Re: **Addendum to Revised Data Gap Workplan**
Douglas Parking Company
1721 Webster Street
Oakland, California
ACEH File No. 129

Douglas Parking
 1721 Webster Street
 Oakland, California

**Proposed Boring & Subslab
 Probe Location Map**

FIGURE
1

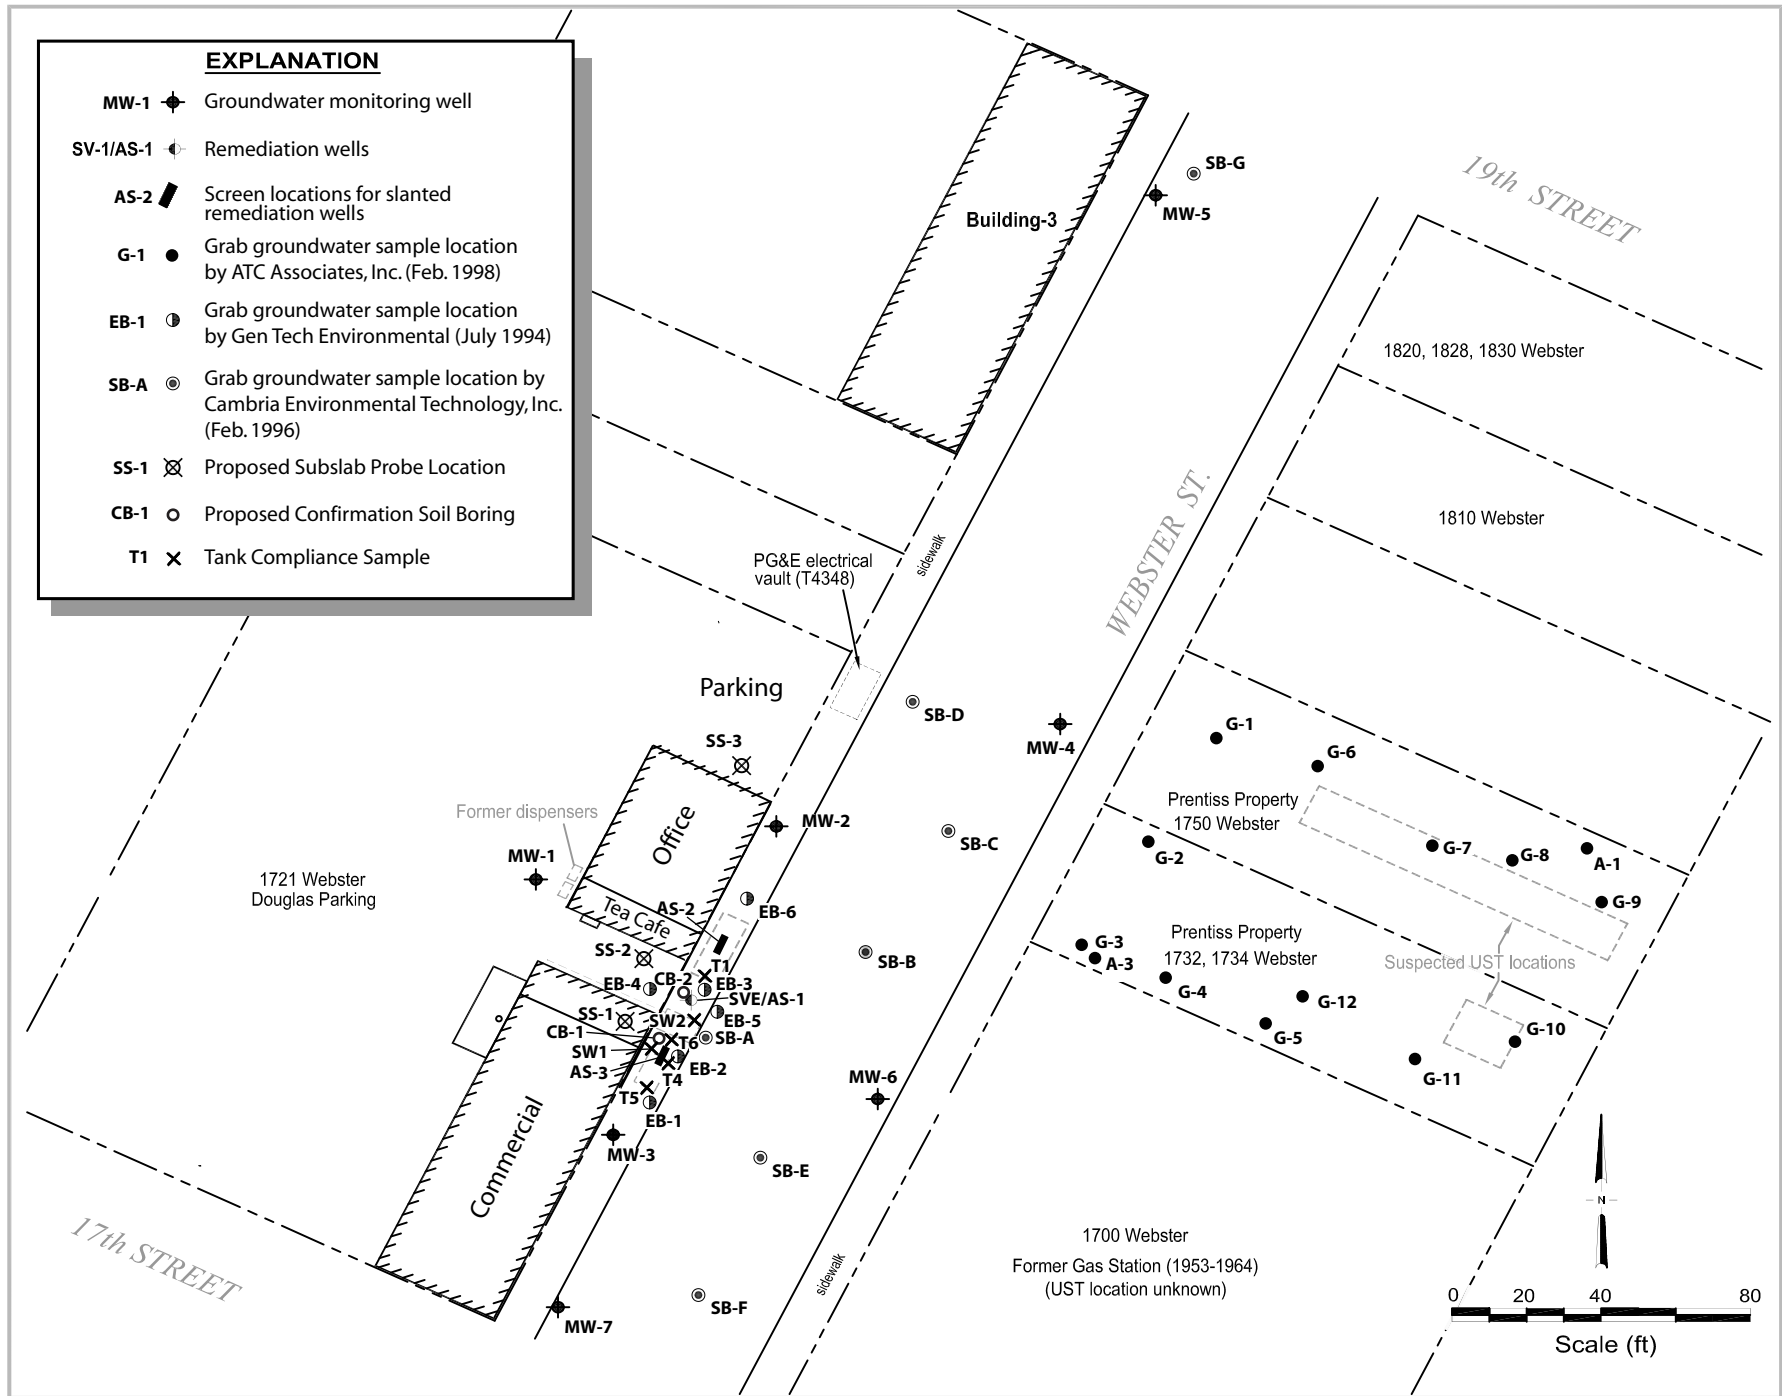
After inspecting the site and reviewing figures of prior sampling and excavation extents, Pangea intends to install one confirmation soil boring (CB-2) between former excavation compliance samples T1 and SW2 instead of installing a third boring (CB-3) near former soil sample SW2 (Figure 1). The installation of a third boring (CB-3) was requested by the Alameda County Environmental Health (ACEH) letter dated September 13, 2013. As depicted on the attached figure, installing two confirmation borings outside the limits of the former excavation (per County request) would result in two borings installed within 5 ft of each other. Additionally, Pangea intends to control project costs by installing boring CB-2 within the well box of well AS-1 or AS-2 to avoid sidewalk flag replacement within the site driveway.
